Site Inspection Report

Site: MORGAN A #1
04/20/2022

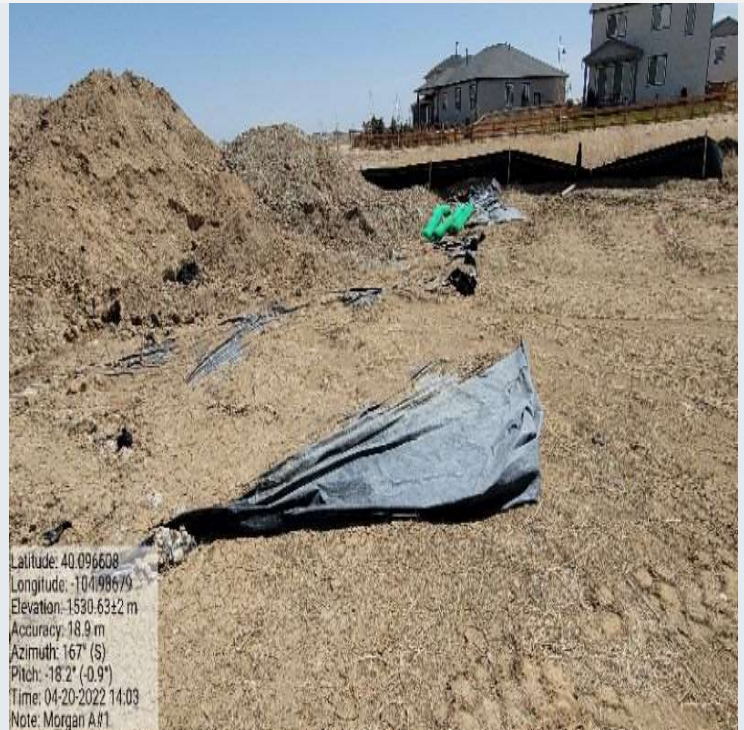
Remediation Activity Checklist	
	Photo
Question: Open excavation? Response: Yes Notes: Flowline exposed and supported. Adequate fencing surrounding excavation.	 <p> Latitude: 40.097056 Longitude: -104.986747 Elevation: 1528.83±2 m Accuracy: 6.3 m Azimuth: 171° (S) Pitch: -25.3° (-0.6°) Time: 04-20-2022 13:57 Note: Morgan A#1 </p>

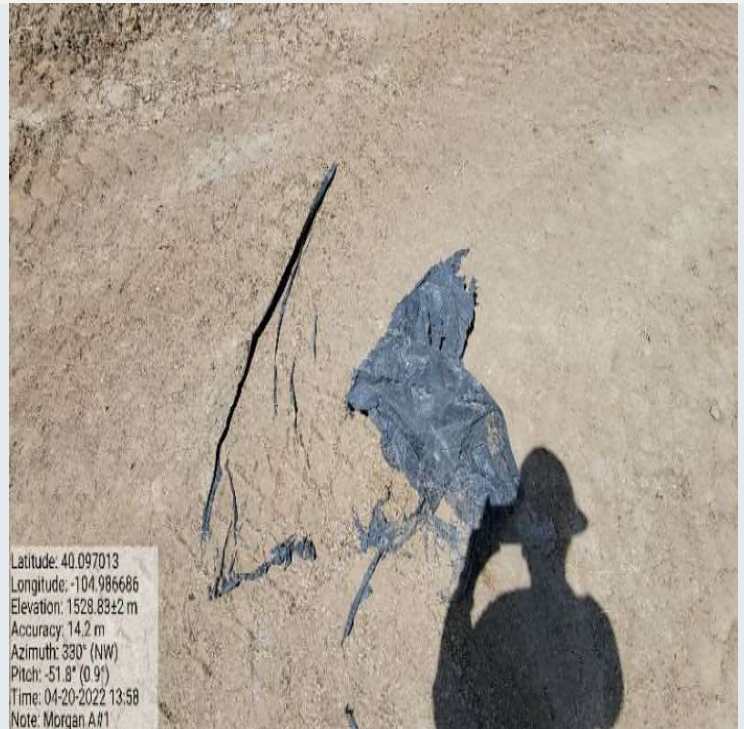
Question: Stockpiled waste?**Response:** Yes**Notes:** Actively being removed and transported offsite. Liners present under stockpiles (One partially torn). Silt fence failing – Other BMPs removed to allow excavator access.**Question:** Stockpiled waste?**Response:** Yes**Notes:** Actively being removed and transported offsite. Liners present under stockpiles (One partially torn). Silt fence failing – Other BMPs removed to allow excavator access.

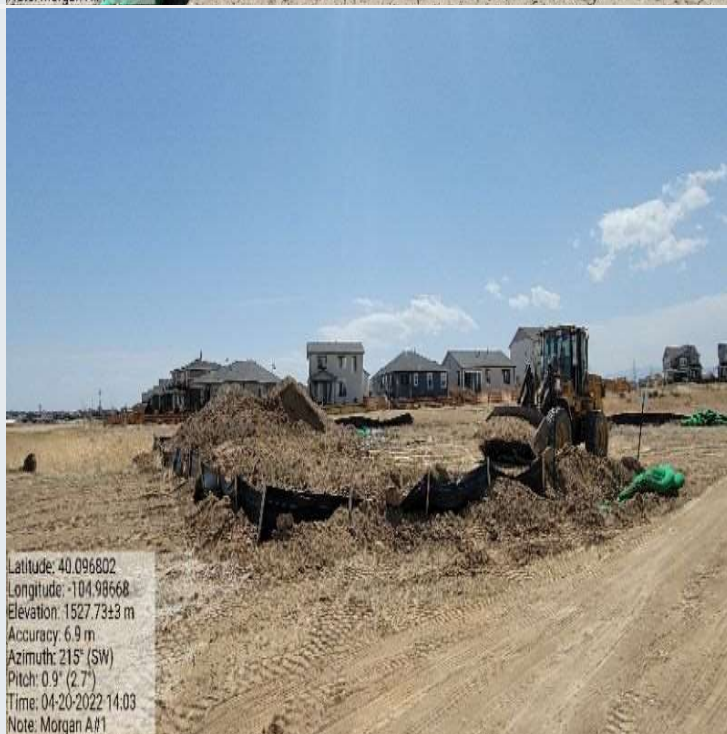
Question: Site is free of debris/trash?

Response: No

Notes: Unused fencing and debris stored onsite.

Question: Potential pollutants (trash, material stockpiles) are properly contained?

Response: No

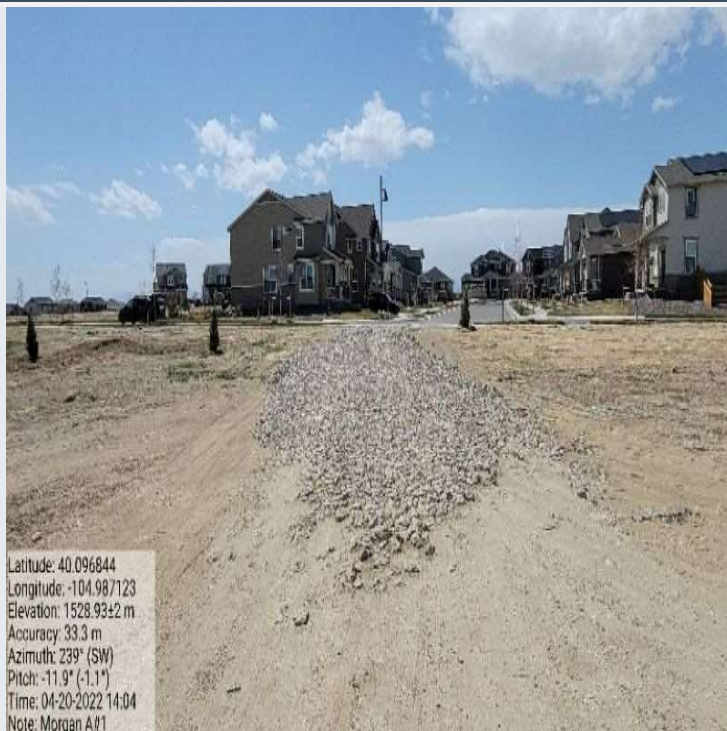
Question: Additional stormwater control measures/maintenance recommended?

Response: Yes

Notes: Repair and/or reinstall all silt fencing surrounding perimeter.
